SUNDRY NOTICES AND REPORTS ON WELLS (DO NOT USE THIS FORM FOR PROPOSALS TO DRILL OR TO DEEPEN OR PLUG BACK TO A DIFFERENT RESERVOIR. USE "APPLICATION FOR PERMIT" (FORM C-101) FOR SUCH PROPOSALS.) 1. Type of Well: Oil Well ☒ Gas Well ☐ Other ☐		WELL API NO. 30-025-38192 5. Indicate Type of Lease STATE ☐ FEE ☐ 6. State Oil & Gas Lease No.
2. Name of Operator Lease Holders Acquisitions		7. Lease Name or Unit Agreement Name Bagley
3. Address of Operator 705 S Mustang rd #127, Yukon, OK 73099		8. Well Number 002
4. Well Location Unit Letter <u>G</u> 1905 feet from the <u>N</u> line and <u>2130</u> feet from the <u>E</u> line Section <u>09</u> Township <u>11S</u> Range <u>33E</u> NMPM County Chaves		9. OGRID Number 372076
11. Elevation (Show whether DR, RKB, RT, GR, etc.)		10. Pool name or Wildcat BAGLEY;PERMO PENN, NORTH

Plug And Abandonment Procedure

Bagley #002

Lea County, NM / API 30-025-38192

Proposed Wellbore Diagram

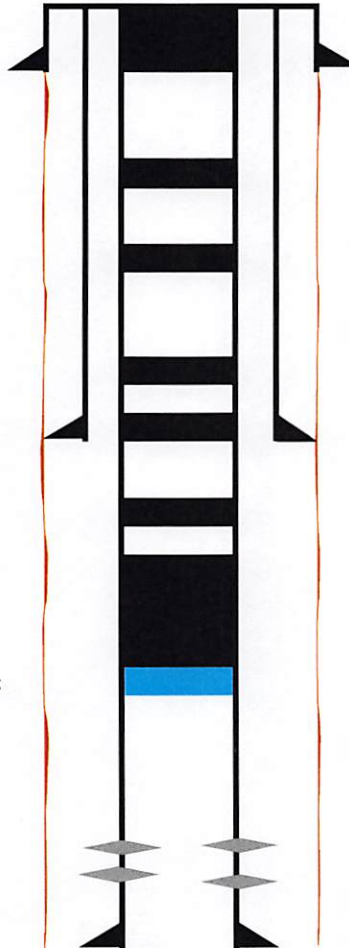
NMOCD plans to plug this well in accordance with the attached procedure and any agreed modifications there to.
In addition to current plug program

Drill out CIBP at 7119 and reset within 100ft of the perforations, and 100ft plug or 25 sacks which ever is greater.

Add cement Plug from 8550 to 8450

Add cement plug from 7378 to 7278

Created By	Condition	Condition Date
jagarcia	See changes made to PA design	10/17/2023
